# UNITED STATES PATENT AND TRADEMARK OFFICE

10/796,471

**Office Action Summary**

## **DETAILED ACTION**

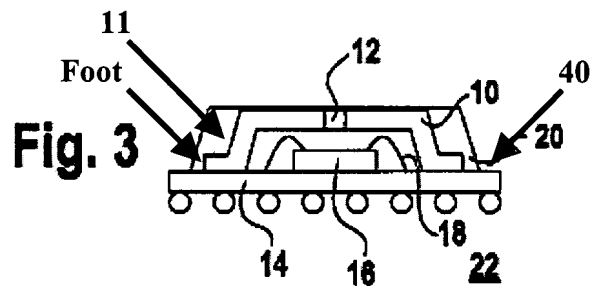
Regarding claim 1, Fishley et al. teaches a package lid for attaching to a package substrate of a packaged semiconductor comprising a sloped wall (11) configured to provide an exposed perimeter portion (40) of the package substrate (14) [see fig. 3, attached below]. With regards to the limitation that the sloped wall is used or configured to provide an exposed perimeter portion when the package lid is disposed on the package substrate, the court has held that a recitation of the intended use of the claimed invention must result in a structural difference between the claimed invention and the prior art in order to patentably distinguish the claimed invention from the prior art. See *In re Pearson* 181 USPQ 641 (CCPA 1974) and *In re Swinehart* 169 USPQ 226 (CCPA 1971). In the instance case, Fishley et al. teaches a sloped wall (11) configured to provide an exposed perimeter portion (40) of the package substrate (14) when the package lid (10) is disposed on the package substrate (14) to allow application of a molding compound (20) on the exposed perimeter portion (40) of the package substrate (14), the molding compound (20) contacting the sloped wall (11) to secure the package lid (10) to the package substrate (14) of the packaged semiconductor (22) [see fig. 3, attached below]. Thus, Fishley et al. anticipates the claimed invention since the prior art structure is capable of performing the claimed intended use.

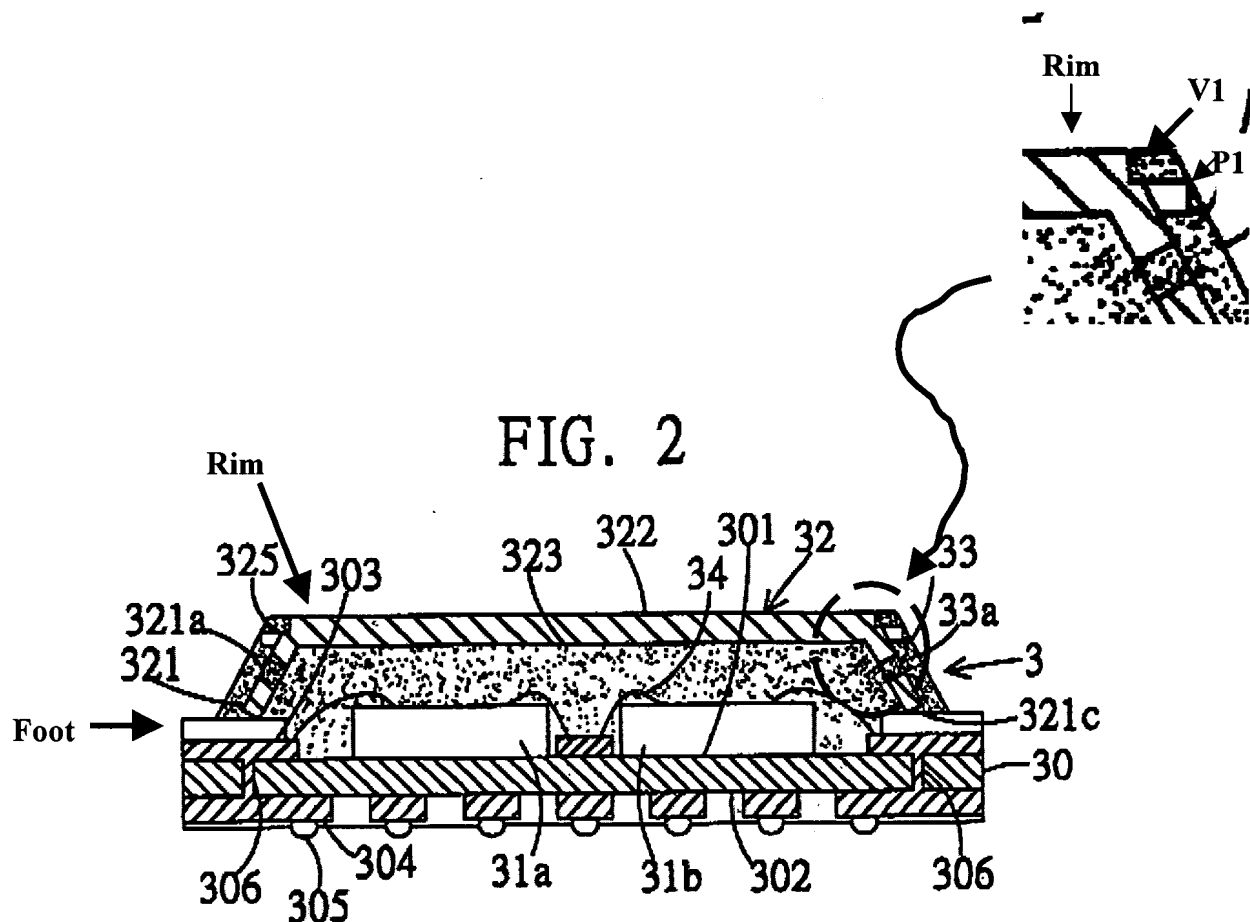
Regarding claim 12, Tang et al. teaches a vertical wall (V1) around a top (322) of the package lid (32) [see fig. 2, attached above].

Regarding claim 13, Tang et al. teaches fiducial marks (consider protrusion P1 or 325) formed in the rim (V1) [see fig. 2, attached above].

Regarding claim 19, Tang et al. teaches a first molding compound (consider the molding compound 33 formed on the sloped wall (321) located on the left side of the structure as shown in figure 2). and a second molding compound (consider the molding compound 33 formed on the sloped wall (321) located on the right side of the structure as shown in figure 2).

Regarding claim 21, Tang et al. teaches a solder ball grid array (305) [see fig. 2].

Regarding claim 11, Fishley et al. fails to teach a gap in the sloped wall. However, Tang et al. teaches the claimed limitation in figure 2. For instance, Figure 2 shows a gap (321a) in the sloped wall (321) of the package lid (32).

FIG.  
2A

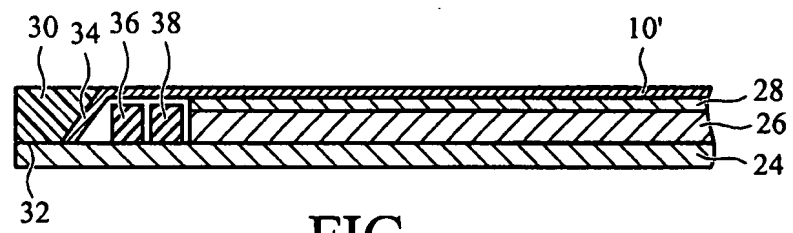
1. The drawings as filed on June 4, 2007 are objected to under 37 CFR 1.83(a) because they fail to show the section line A-A' in figure 2B and the reference sign 35 in figure 2A as described in the amended specification as filed on December 18, 2006. Any structural detail that is essential for a proper understanding of the disclosed invention should be shown in the drawing. MPEP § 608.02(d). Corrected drawing sheets in compliance with 37 CFR 1.121(d) are required in reply to the Office action to avoid abandonment of the application. Any amended replacement drawing sheet should include all of the figures appearing on the immediate prior version of the sheet, even if only one figure is being amended. The figure or figure number of an amended drawing should not be labeled as "amended." If a drawing figure is to be canceled, the appropriate figure must be removed from the replacement sheet, and where necessary, the remaining figures must be renumbered and appropriate changes made to the brief description of the several views of the drawings for consistency. Additional replacement sheets may be necessary to show the renumbering of the remaining figures. Each drawing sheet submitted after the filing date of an application must be labeled in the top margin as either "Replacement Sheet" or "New Sheet" pursuant to 37 CFR 1.121(d). If the changes are not accepted by the examiner, the applicant will be notified and informed of any required corrective action in the next Office action. The objection to the drawings will not be held in abeyance.
